ACKNOWLEDGED
Response to Request for Additional Info
Forwarded By R.A. Purple's ltr of
9-8-75 concerning Topical Report
BAW-10103

Re: Oconee Nuclear Station
Docket Nos. 50-269, -270, -287

RESPONSE TO REQUEST FOR ADDITIONAL INFORMATION
FORWARDED BY MR. R. A. PURPLE'S LETTER OF
SEPTEMBER 8, 1975

FIGURE 1
FAN COOLER HEAT REMOVAL RATES

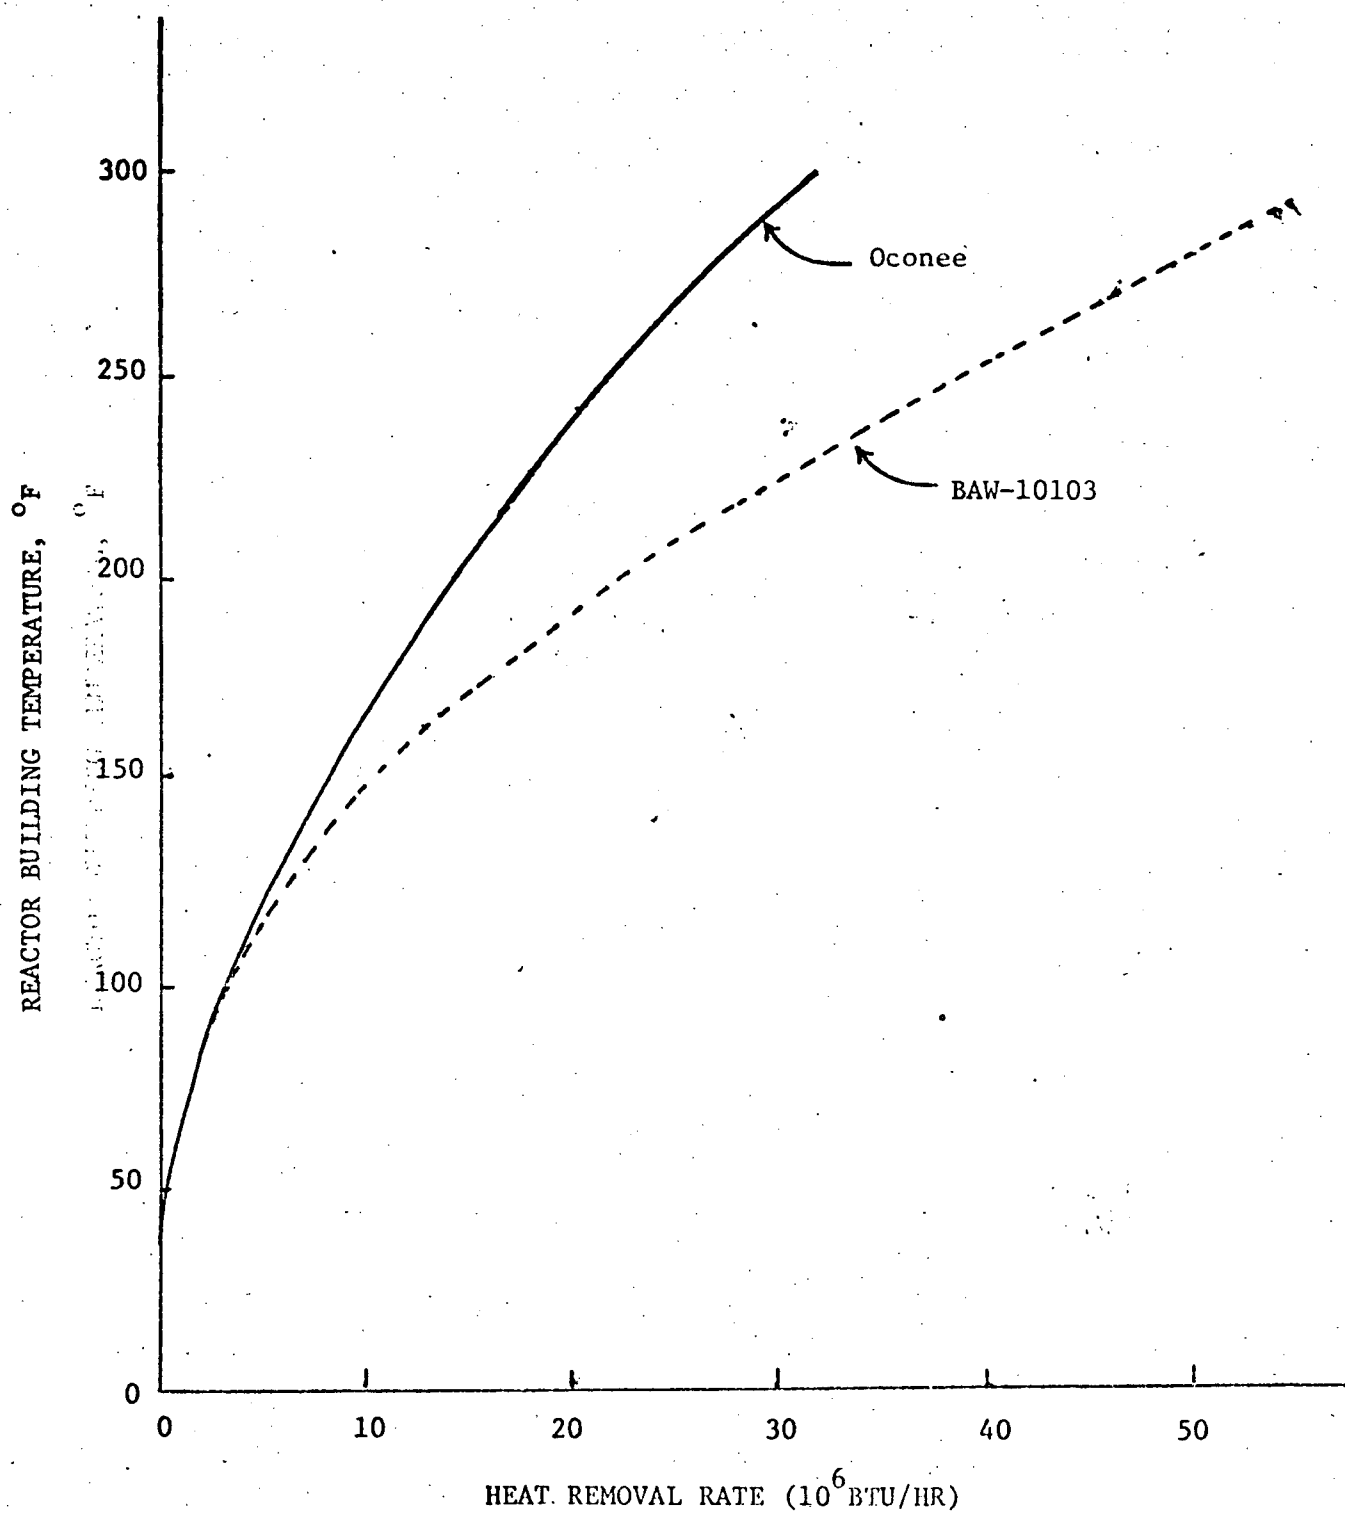
Fan-Cooler Heat Removal Rate - Compare the maximum fan-cooler heat removal rate for your plant with that assumed in BAW-10103. Show that minimum operational values of service water temperature have been used.

The maximum fan-cooler heat removal rate obtained from data presented in the FSAR and modified for 40°F cooling water temperature is compared to that used in BAW-10103, in Figure 1. As can be seen from this comparison, the fan cooler heat removal rate assumed in BAW-10103 is equal to or greater than

that for Oconee at any given containment (RB) atmosphere temperature. The service water temperature used in both cases is 40F, however, the minimum operational value stated in the FSAR is 45F thereby adding additional conservatism.
